A Low-cost and Shielding-free Ultra-low-field Brain MRI Scanner

Review for NCOMMS-21-28454: "A Low-cost and Shielding-free Brain MRI Scanner for Accessible Healthcare"

#### RESPONSES AND REVISION OF NC MANUSCRIPT # NCOMMS-21-28454

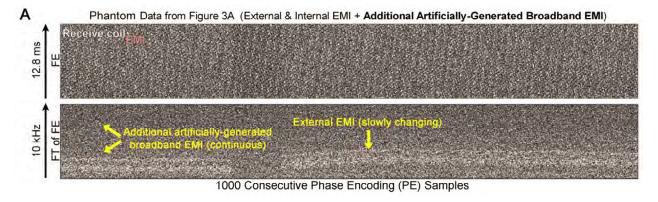
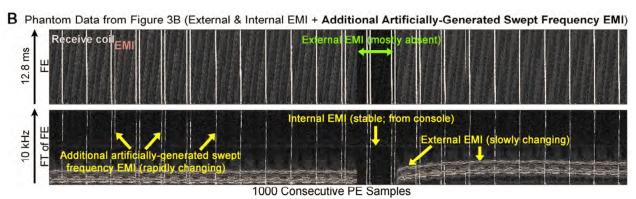
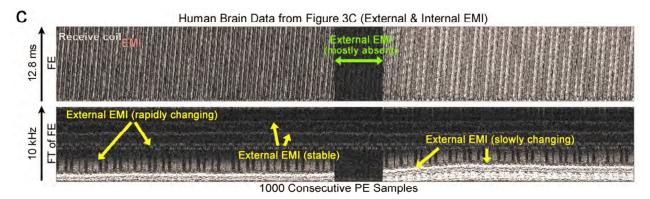
R1-1a It is claimed that "the deep learning EMI cancellation procedure is able to eliminate the undesirable EMI signals in a highly reliable and robust manner even when environmental EMI sources and their spectral characteristics changed dynamically during scanning". This is a strong claim and indeed essential for real-world deployment of the scanner. However, I did not see any experiments and results that specifically tested the impact of EMI that changed dynamically during a scan. This could be done either with a simulation, where EMI is introduced only during short randomly selected periods during the scan, and/or with an experiment with an EMI source that can be turned on and off during the scan.

- iii. The experimental data shown in main Fig. 3 did contain EMI signals from different sources that varied dynamically during scan. We apologize for not explicitly showing the temporal characteristics of the raw k-space data in our original submission. **Figs. R1-1a-1**, **2**, **3** and **4** below present the analyses of the raw data acquired under the three conditions that correspond to the main Fig. 3.

As shown in **Figs. R1-1a-1** and **R1-1a-3** below, in absence or presence of MRI signals (i.e., RF transmit power off or on) and before EMI elimination, one can easily discern and identify numerous sources of external (environmental or/and artificially generated) EMI and internal (e.g., from console) EMI. They were indeed not static across the duration of each scan. For example, it can be clearly seen from the frequency spectra (i.e., Fourier transform of frequency encoding line, or FT of FE) that spectral characteristics of some EMI sources changed dynamically, either slowly or very rapidly, over time during scan. The results after EMI cancellation (shown in **Figs. R1-1a-2** and **R1-1a-4** below), together with the image and spectral results in Fig. 3, clearly demonstrate the effectiveness of the proposed deep learning EMI cancellation method in presence of diverse and dynamically varying EMI signals.

v. In this revision, we have included Figs. R1-1a-1 and R1-1a-2 above as the new Supplementary Figs. 1 and 2 to illustrate the dynamically varying nature of the EMI signals in main Fig. 3, and revised the text accordingly.

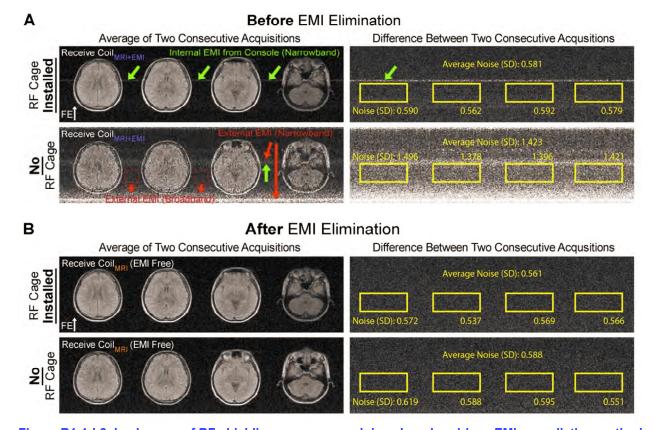
**R1-1d** It is claimed that the EMI cancellation procedure "obtained phantom and brain image SNRs that were ≥95% of those when using a fully enclosed RF shielding cage for direct comparison." Since no comparison to an acquisition with an RF-shield was performed, this statement should be removed.

- i. We apologize to the reviewer here for not including any data to support this statement in the original submission.
- ii. We indeed performed such experiments. We directly compared the two scenarios, where a fully enclosed RF shielding cage was installed or removed, respectively, as illustrated in Fig. R1-1d-1 below. Fig. R1-1d-2 below show the measurements and analyses to quantify the EMI noise levels in the images.

As quantified and demonstrated in **Fig. R1-1d-2** below, our proposed deep learning driven EMI cancellation method was able to provide nearly complete removal of EMI noise in the final images. That is, in absence of EMI shielding cage, our method produced final image noise levels as low as those obtained using a fully enclosed RF shielding cage (*within 5% range*) in human brain experiments. Note that we conducted this experiment using the 3D FSE FLAIR protocol for its acquisition speed (due to its short TR, i.e., 5 mins total scan time for NEX = 2).

iii. In this revision, we have included the results in **Fig. R1-1d-2** above as a new **Supplementary Fig. 3**. We have also clarified the relevant statements in the '0.055 T brain ULF MRI system hardware design' subsection of the results section.

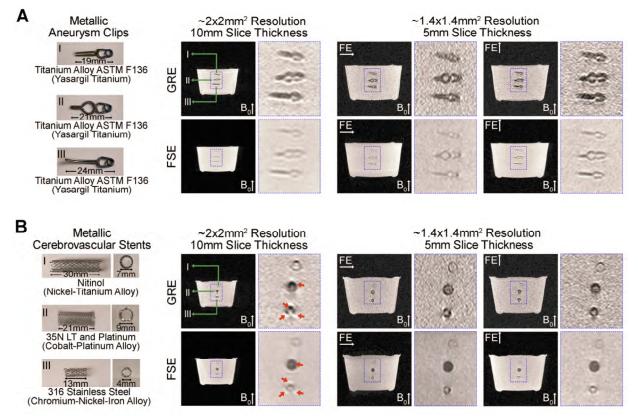
#### **R1-6** Please indicate the direction of the B<sub>0</sub> field in Figure 8?

i. The direction of B<sub>0</sub> field is along the vertical direction for all axial 3D GRE T1W and 3D FSE T2W images in Fig. 8. See **Fig. R1-6** below, where B<sub>0</sub> field direction is indicated.

ii. In this revision, main Fig. 8 has been replaced with Fig. R1-6 above.
